# Proposed Desired Future Condition(s) for Aquifer(s) in GMA 12

## Environmental Stewardship Comments To District Boards Submitted July 22, 2021

**Predicted reduction of discharge of groundwater into the mainstream Colorado River due to Current DFC Run 3 and Proposed DFCs S-12 (George Rice, New GAMs).**

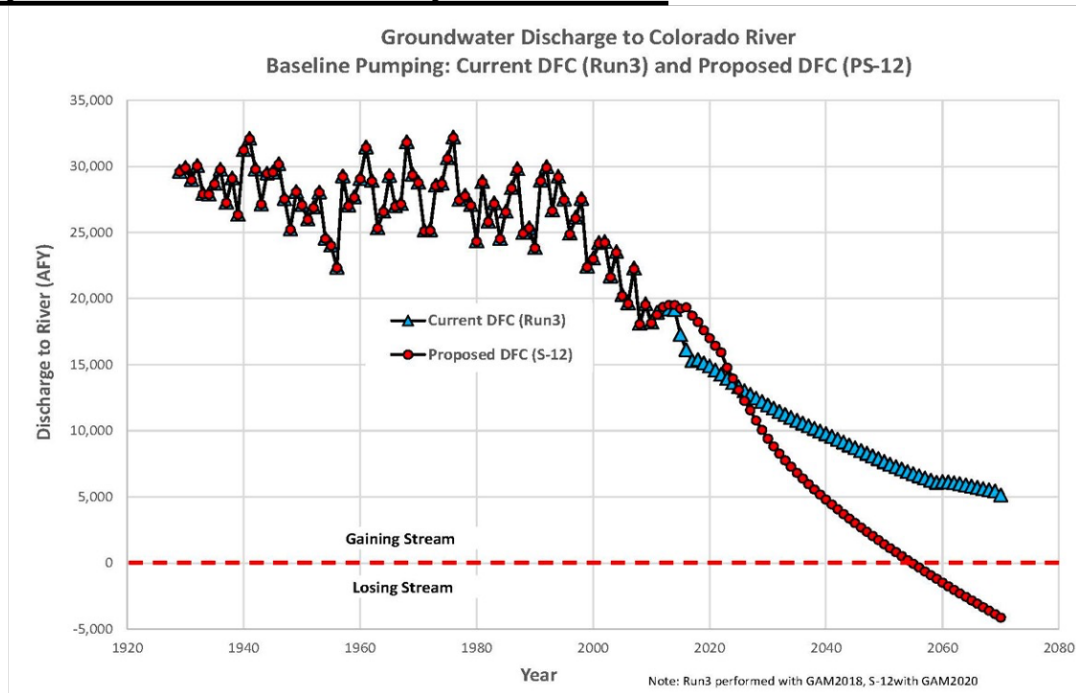
This graphic represents the impacts that are predicted by the new GAM. The graph shows the relationship between the pumping associated with each DFC and the impact on outflows to the Colorado River

- Blue is the Currently Adopted 2017 DFCs as depicted by Run 3 using the NEW GAM.
- Red is the Proposed DFCs based on Scenario S-12.
- The Historical Calibration period is from 1930 to 1995
- The Developmental Period is 1995-2070
- Gaining Stream vs Losing Stream Redline

Comparing the two runs we see that the greater the amount of groundwater being pumped, the greater the reduction in discharge from the aquifers to the main stem of the Colorado River. This trend toward reversing the groundwater-surface water relationship over the next 50 years is undisputed. This is an example of how the model serves to demonstrate the difference between these two runs, in this case the two DFCs. The key difference is that the Current DFCs do not cause the relationship between the river and the aquifer to reverse, whereas the S-12 Scenario causes the river to change from a gaining to a losing stream somewhere in the 2050-60 timeframe.
